Access Compliance Report

Public Rights-of-Way

Intersection ID: 4891	Main Street: GRANARD_LN	Cross Street: PAINTED_PONY_CT	Location: NW
ADA ID: 9A3A50F6D92C	Ramp Type: Perp	Initial Pass/Fail: Fail	Overall Compliance: No
Codes/Mitigation Info/Possible Solution		Field Measurements/Component Compliance	
Severity Score: 13.75

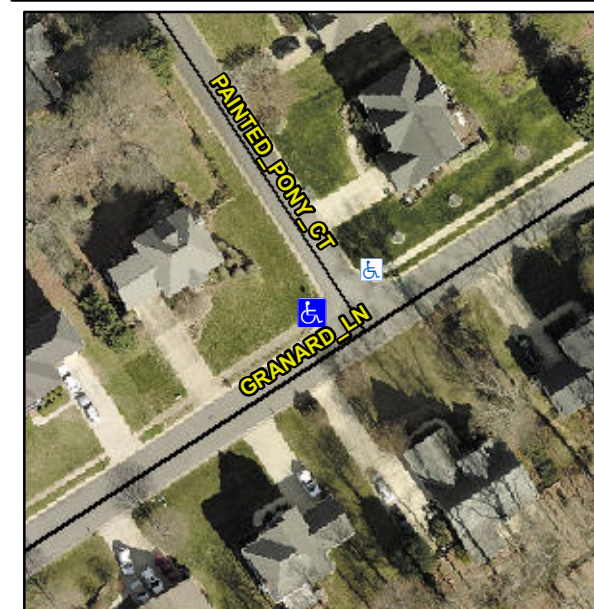
Not Found, R304.2.2, R304.5.3

Compliance	Description	Data	Compliance	Description	Data
N/A	Ramp Length (in)	49.0	No	Ramp Slope (%)	10.2
Yes	Ramp Width (in)	49.0	No	Ramp XSlope (%)	3.4
N/A	Flare Type LT	N/A	N/A	Flare Type RT	N/A
N/A	Flare Slope LT (%)	N/A	N/A	Flare Slope RT (%)	N/A
N/A	Flare Traversable LT?	N/A	N/A	Flare Traversable RT?	N/A
N/A	Landing Length (in)	N/A	N/A	DWS Provided?	N/A
N/A	Landing Width (in)	N/A	N/A	DWS Contrast?	N/A
N/A	Landing Slope (%)	N/A	N/A	DWS Length (in)	N/A
N/A	Landing X Slope (%)	N/A	N/A	DWS Full Width?	N/A
N/A	Landing Curb? (Y/N)	N/A	N/A	DWS Offset (in)	N/A
N/A	Shared Landing?	N/A			
N/A	Gutter Ponding?	N/A	N/A	Gutter Slope (%)	N/A
N/A	Gutter Lip Ht (in)	N/A	N/A	Gutter X Slope (%)	N/A
N/A	Painted X Walk1?	No	N/A	Painted X Walk2?	N/A
	X Walk 1 Direction	To NE		X Walk 2 Direction	N/A
N/A	X Walk 1 Width (in)	N/A	N/A	X Walk 2 Width (in)	N/A
	X Walk 1 Slope (%)	3.5		X Walk 2 Slope (%)	N/A
	X Walk 1 X Slope (%)	3.5		X Walk 2 X Slope (%)	N/A

Remove & Replace Entire Ramp.
